REQUEST FOR COMMENTS

UNIFORM STANDARD DRAWING NO. 236, "SIDEWALK DRAIN"

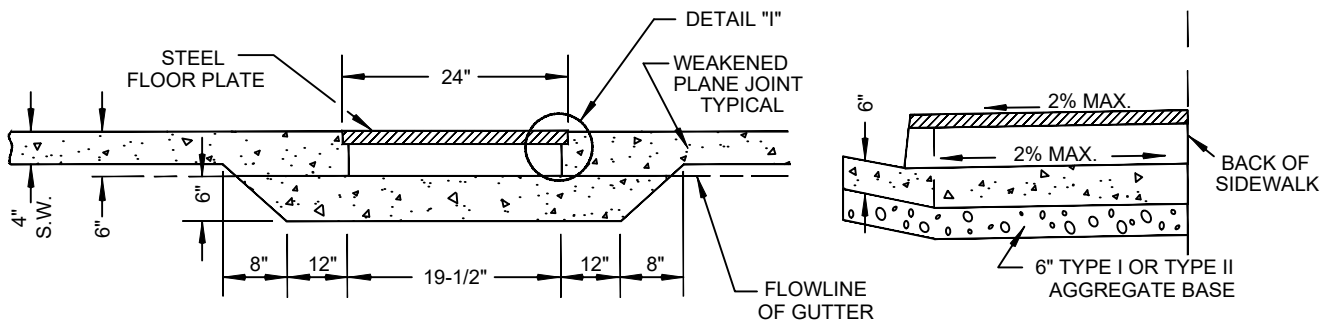
The Specifications Subcommittee of the Executive Advisory Committee to the Regional Transportation Commission of Southern Nevada has approved a proposed revision to Uniform Standard Drawing No. 236 of the Uniform Standard Drawings for Public Works Construction Offsite Improvements, Clark County, Nevada to undergo an industry review process. The proposed revision will reduce the thickness of the steel floor plate.
